**RE: Proceeding on Motion of the Commission to Implement Transmission Planning
Pursuant to the Accelerated Renewable Energy Growth and Community Benefit
Act; Docket No. 20-E-0197**

CASE 20-E-0197

Comments on Joint Utilities' Revised Coordinated Grid Planning Proposal

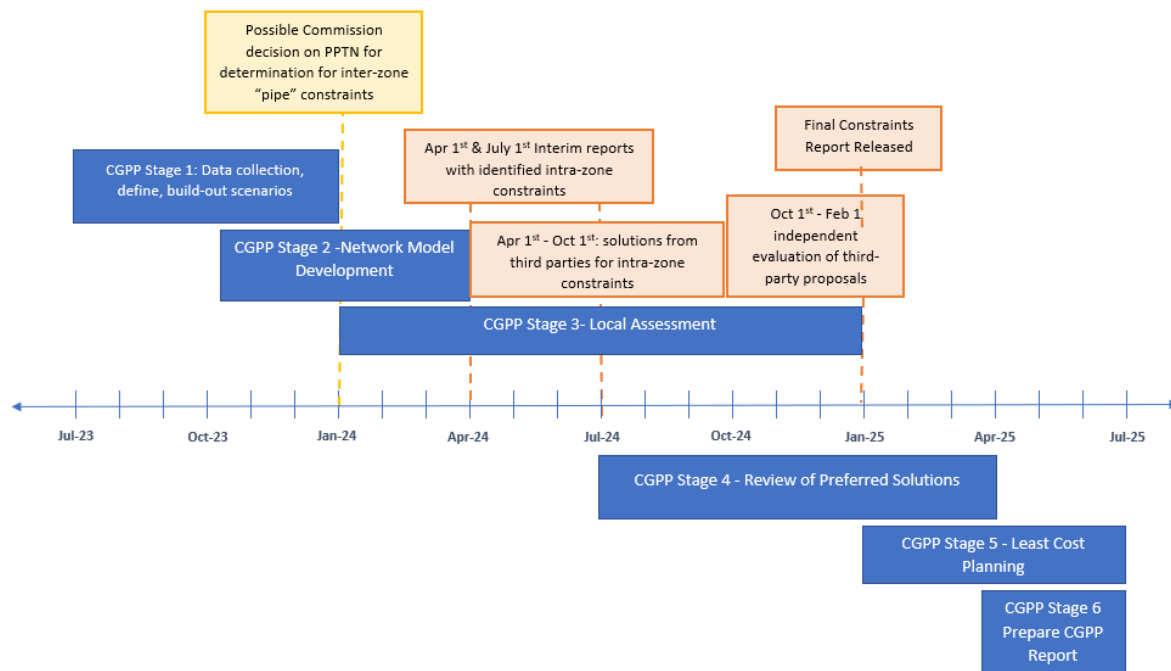
Utilities note that the CGPP report will identify any bulk limitations identified across different stages of the CGPP. However, their proposal seems to be overly limiting their consideration of bulk power solutions to inter-zonal transmission needs. While these types of needs are important, and can be readily identified and proposed for a PPTN in Stage 1, there are many other needs, such as multiple overloads in a single zone identified in Stage 3, that might be better addressed by high voltage or bulk power solutions or a hybrid solutions that also warrant consideration of bulk solutions or a PPTN. Failure to address bulk limitations could ultimately reduce the value of any CGPP transmission solution and increase costs to ratepayers. A broader evaluation of solutions should also be achieved by expanding the CGPP process to enable third party proposals to be submitted and evaluated by an independent entity or via a PPTN process provided it can be run in parallel to the CGPP process to allow comparison of all solutions as part of the Stage 5 of the CGPP process.

Our organizations have developed the figure below to illustrate our recommendation. As shown, the CGPP should include a component whereby a third-party could identify and propose transmission solutions (beyond these proposed by the utilities) in Stage 3, likely with a high-voltage or bulk component for intra-zonal constraints. If any such solutions are proposed, the NYISO or a qualified third-party evaluator would assess all proposed solutions to preserve neutrality and confidentiality of the proposals. Such component would be kicked off as part of CGPP Stage 3: Local Assessment following interim reports by local utilities of identified local constraints with priority given to constraints meeting the loading criteria defined above. As illustrated in the figure below, such an interim report would be released by April 1st and July 1st of year 1 with a final report to be released by the end of Stage 3; while solutions by third parties would be submitted through October of year 1. A third-party evaluator or NYISO would then evaluate such proposals from October 1st through February 1st of year 2, when CGPP Stage 5 commences.
